FORM APPROVED
OMB NO. 1004-0137
Expires: January 31, 2018**SUNDRY NOTICES AND REPORTS ON WELLS**
*Do not use this form for proposals to drill or to re-enter an abandoned well. Use form 3160-3 (APD) for such proposals.***SUBMIT IN TRIPLICATE - Other instructions on page 2**

RKI EXPLORATION & PRODUCTION, LLC REQUESTS APPROVAL TO P&A THE ABOVE WELL.

**Santa Fe Fed. #2
Current WBD**

Santa Fe Fed # 2 Plug and Abandon Procedure

Santa Fe Fed. #2
Proposed WBD

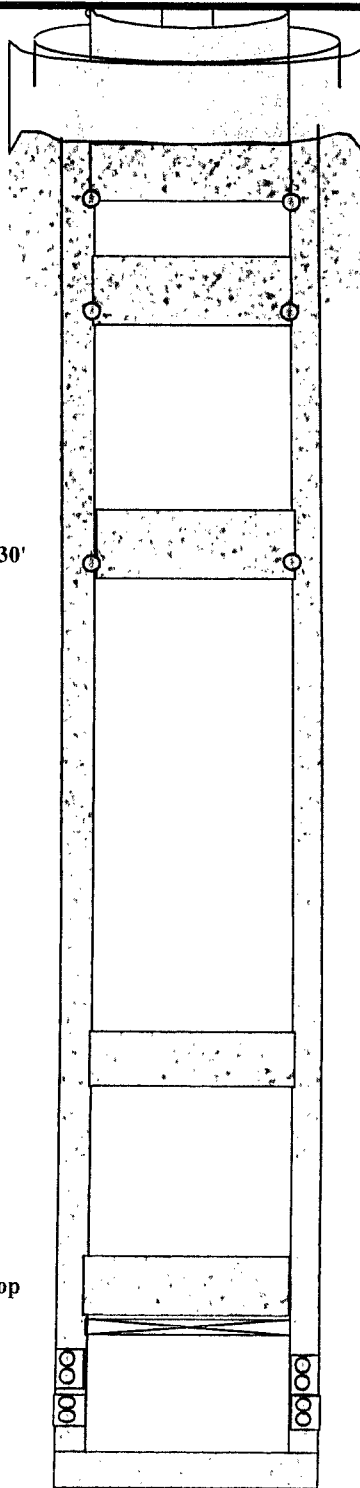
Cmt'd w-300 sxs to surface ✓ 456

5 1/2" (7 7/8" hole) 15.5# csg. to 6,350' ✓ 6361

Cmt'd w-1805 sxs. to surf. ✓

DV Tool @ 5,100' ✓

TD @ 6,361' ✓

T/salt 500

B/salt 2360

Del. 2730

5941' - 5,998' ✓

6,116' - 6,188' ✓

BS 6274
